Memorandum

Date: September 14, 2022

Subject: MASH Box Beam Terminal-MBEAT, and MASH Box Beam Updates

Example 13-7: Box Beam Guardrail (revised version from RDM, appx. K)

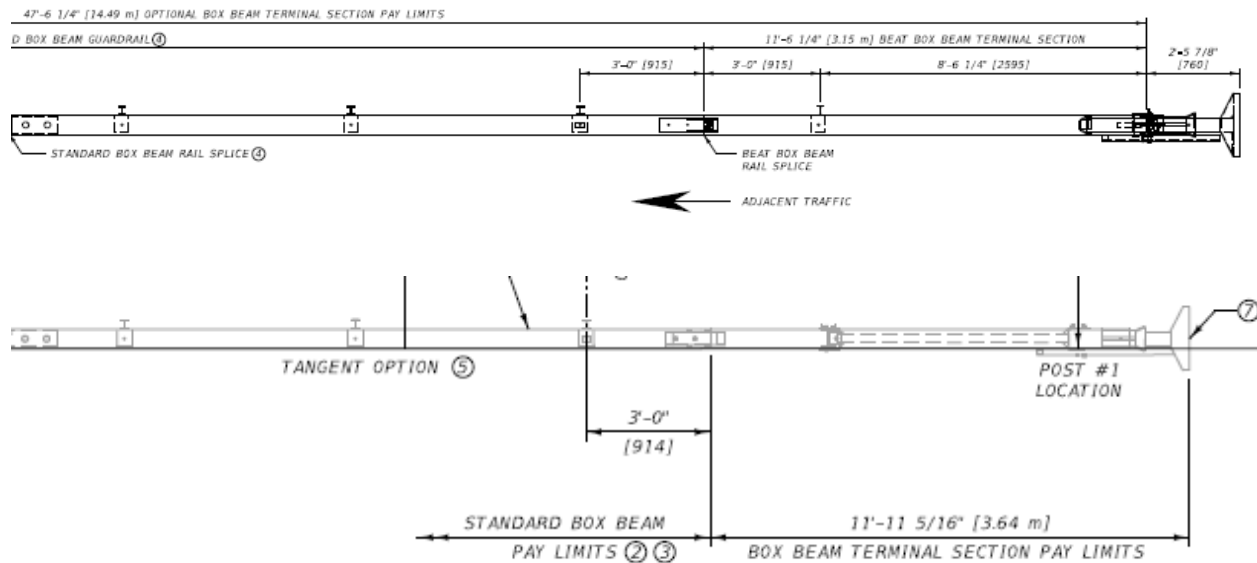
Given: Length of need for barrier is determined to be between Stations 17+50.00 and 32+75.00. Box Beam guardrail will be used to shield the hazard(s). The facility is a two-lane, two-way roadway requiring an MBEAT terminal at each end, and there is a private approach at station 33+40 on the same side of the roadway as the guardrail.

Problem: Determine the beginning and ending stations and the length of rail for payment.

1. $[(32+75.00) - (17+50.00)] + (2) \times (3.0' \text{ reduction in LON at each MBEAT connection}) \div 18' \text{ increment} = 85.06 \text{ sections, Round } 86 \text{ sections of Box Beam guardrail} \Rightarrow$
2. $86 \times 18' = 1,548.0' \text{ Payment Length of Box Beam Guardrail}$
3. Because of the approach located at station 33+40, locate the rail as far back on stationing as possible to reduce impacts to sight distance and turning maneuvers associated with the approach.

$[32+75.00] + 14.9' \text{ for MBEAT/Box Beam outside of length of need} = 32+89.90 \text{ Ending Station}$
 $[32+89.90] - 1,548.0' \text{ of standard run rail} - (2 \times 11.9' \text{ MBEAT length}) = 17+18.10 \text{ Beginning Station}$
4. Includes 2 each MASH BOX BEAM TERMINAL - MBEAT

Note that the difference between the results here and the original design with OTS terminals is very slight (original was station 17+17.80 to 32+90.20) and the overall length of the run is reduced. The original stations also are measured to the first post of each OTS, rather than the end of the impact head, which we've included with the MBEAT length/stationing here. The original calcs also used the slightly longer WY-BET length of 48.2' and shorter length of full-strength rail, although this option has been unavailable for some time. The detailed drawings will be modified to indicate the end of the impact head as the end station shown in the plans, rather than the location of the first post.
